SUBJ: **Addendum 2 – New Bid Opening Date and Clarifications to the Specifications**

BID ITEM: **Bid Item #23-150 Construction - Airfield Electrical System Upgrade for Runways 5-23 & 11-29 for Augusta, GA – Daniel Field Airport**

**ADDENDUM NO. 2**

**GE1**  
Sheet 11 of 52

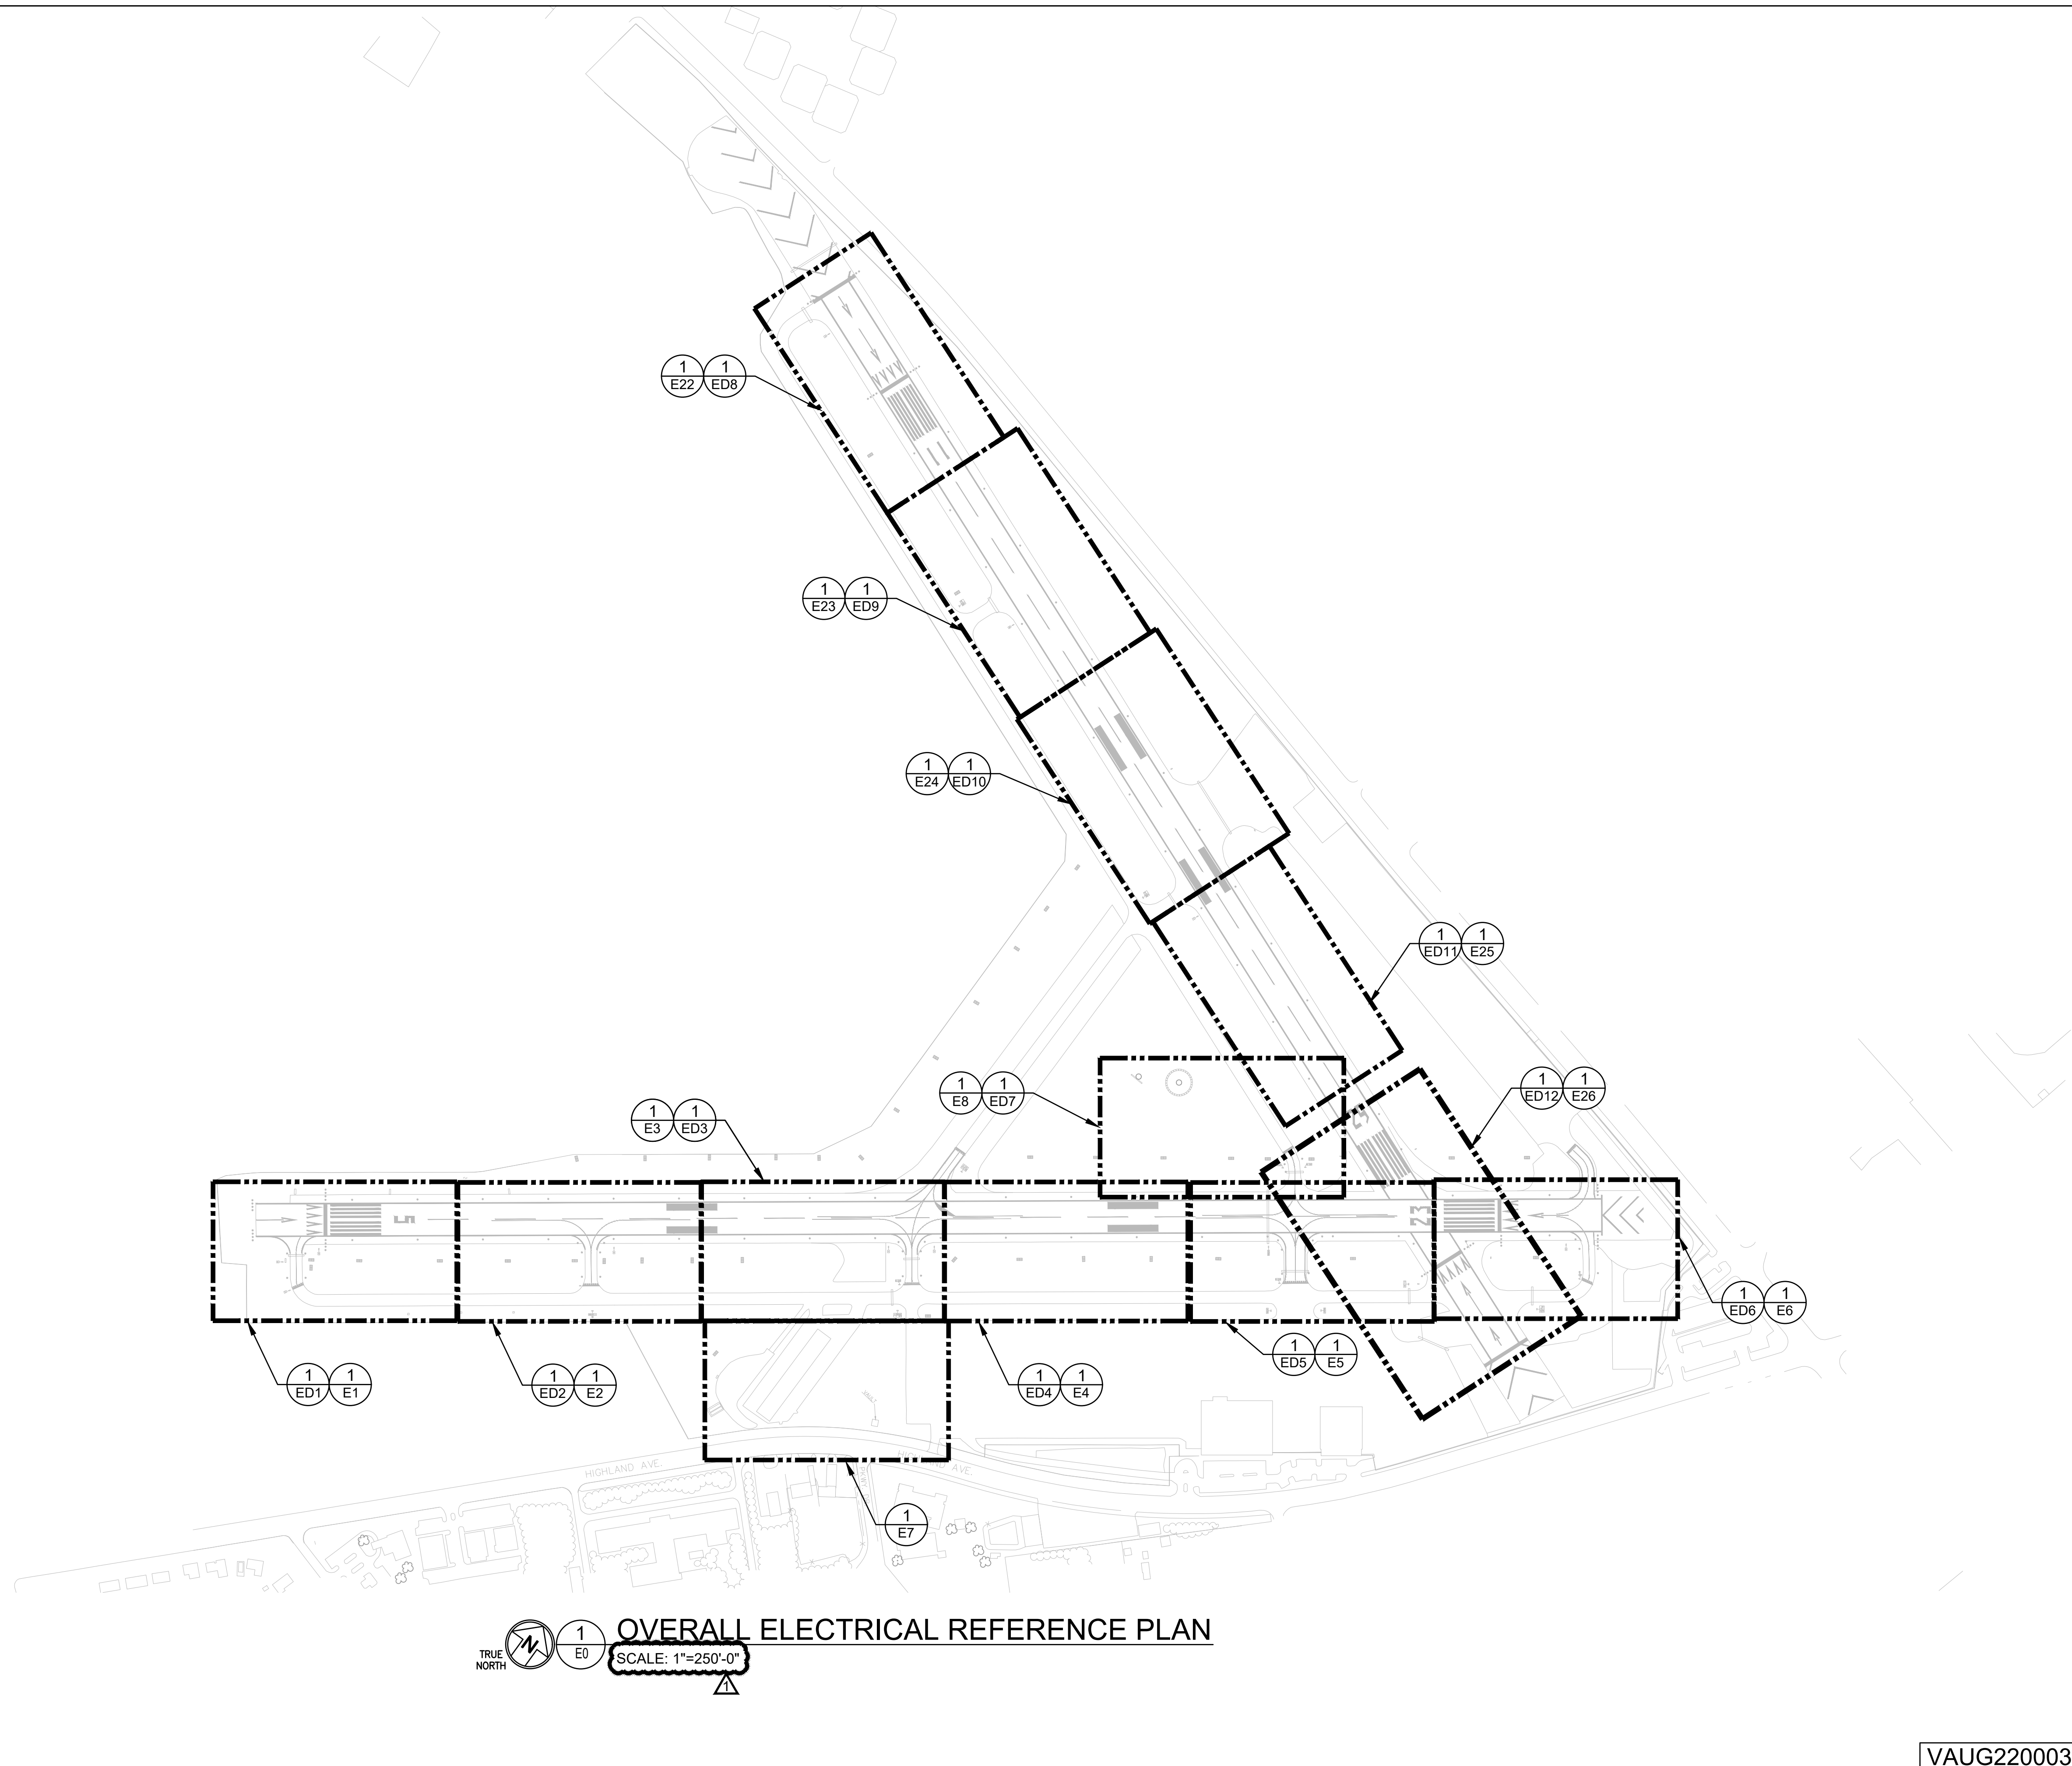
- A. **Replace Sheet GE1** – Electrical Legends & Notes with revised Sheet GE1 attached to this Addendum 2.
  - Added General Electrical Note 26.
- B. **Replace Sheet E1** – Airfield Lighting & Wiring Plan – Runway 5/23 – Part 1 with revised Sheet E1 attached to this Addendum 2.
  - Added note on REIL Sync Cable Keynote 1 stating "Route cable around Runway 5 end threshold as required".
- C. **Replace Sheet E6** – Airfield Lighting & Wiring Plan – Runway 5/23 – Part 6 with revised Sheet E6 attached to this Addendum 2.
  - Added one (1) REIL light on opposite of Runway 23 end.
  - Added Keynote 7.
  - Added one (1) Runway 5-23 edge light.

**E7**

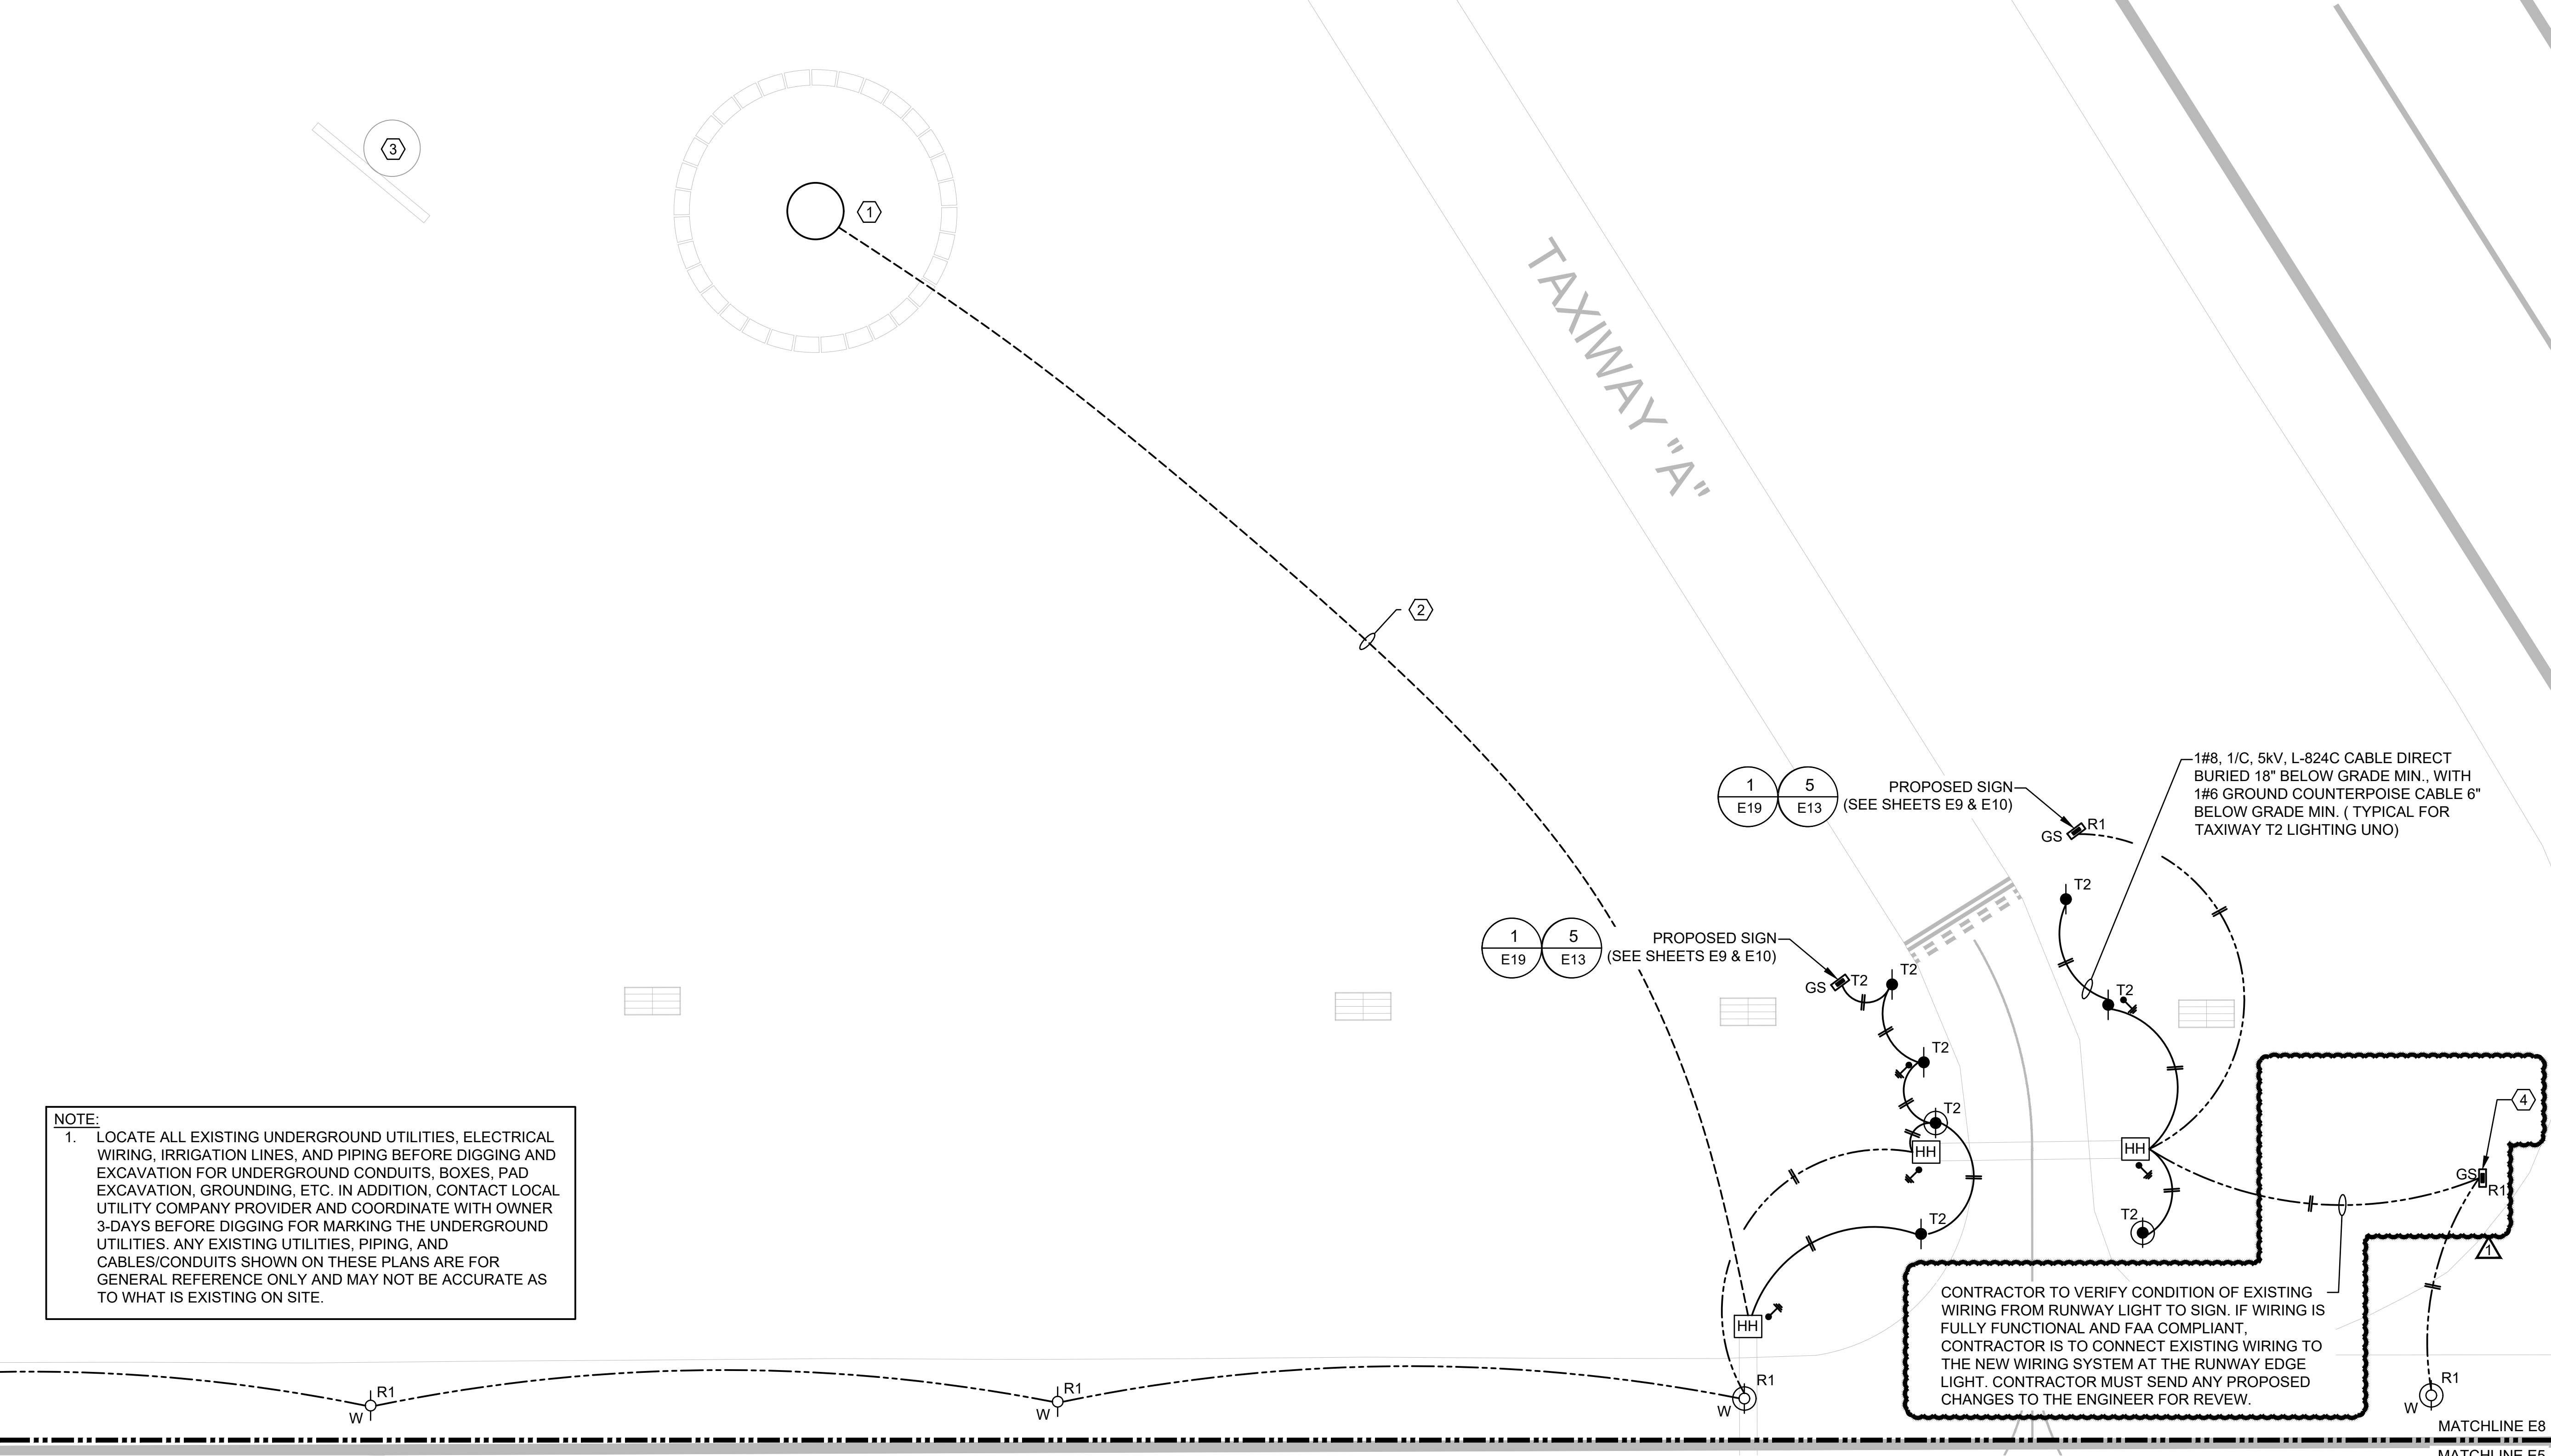
- D. **Replace Sheet E7** – Airfield Lighting & Wiring Plan Runway 5/23 – Part 7 with revised Sheet E7 attached to this Addendum 2.
- Conduit size for Wind cone Circuit revised to 1” C.
- E. **Replace Sheet E22** – Airfield Lighting & Wiring Plan –Runway 11/29 - Part 1 (ADD) with revised Sheet E22 attached to this Addendum 2.
- Keynote 1 revised to add note stating “ Route cable around Runway 11 end threshold as required.”
  - General Note has been revised, See Section III Clarification Notes of this Addendum 2.
- F. **Replace Sheets E23-E26** – Airfield Lighting & Wiring Plan –Runway 11/29 - Parts 2-5 (ADD) with revised Sheets E23-E26 attached to this Addendum 2.
- General Note has been revised, See Section III Clarification Notes of this Addendum 2.
